APPLICATION NO.	FILING DATE	FIRST NAMED INVENTOR	ATTORNEY DOCKET NO.	CONFIRMATION NO.
09/480,588	01/10/2000	ROBERT LEONARD FULKS	9D-HR-19163-	4504
7590..	08/26/2004		EXAMINER	
			JEFFERY, JOHN A	
			ART UNIT	PAPER NUMBER
			3742	
DATE MAILED: 08/26/2004

Office Action Summary	Application No.	Applicant(s)
	09/480,588	FULKS, ROBERT LEONARD
	Examiner	Art Unit
	John A. Jeffery	3742

DETAILED ACTION

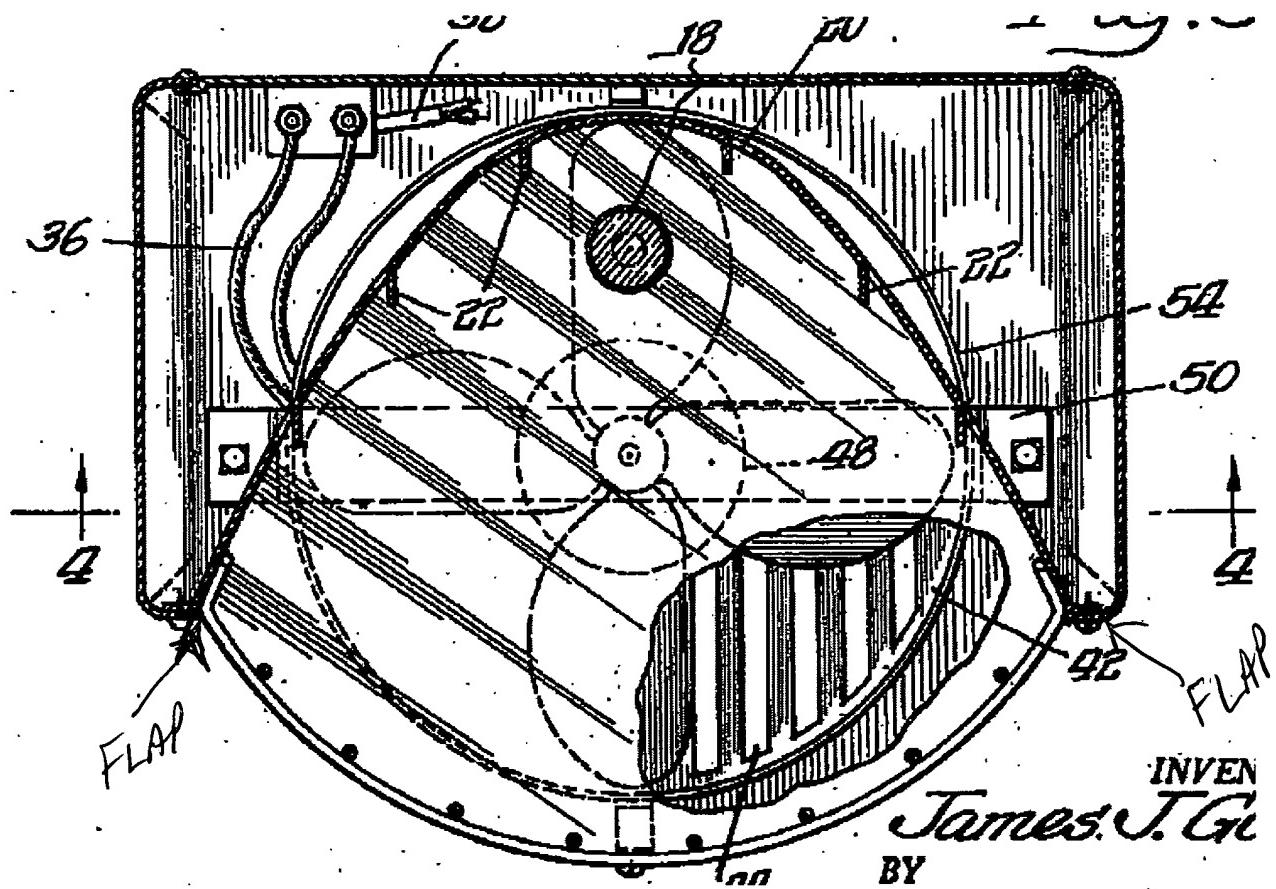
Claims 1-8, 10, 11, and 13-16 are rejected under 35 USC 102(b) as being anticipated by Gough (US 2,410,211). The scope and breadth of the claim language did not preclude the citation of Gough (US 2,410,211) who discloses a reflective "bracket" 14 comprising a parabolic channel with longitudinal ventilation openings 20. See Figs. 1-3. Each ventilation opening has a "shield" 22 integral with the channel. Lateral openings 26 extend along opposite sides of the channel. Regarding claim 7, note the unlabeled "flap" extending from the channel sides as indicated on an enlarged reproduction of Fig. 3 of Gough (US 2,410,211) below.

Also, regarding claim 15, "holding bracket" 24 extends from the channel and comprises a plurality of "fingers" 28.
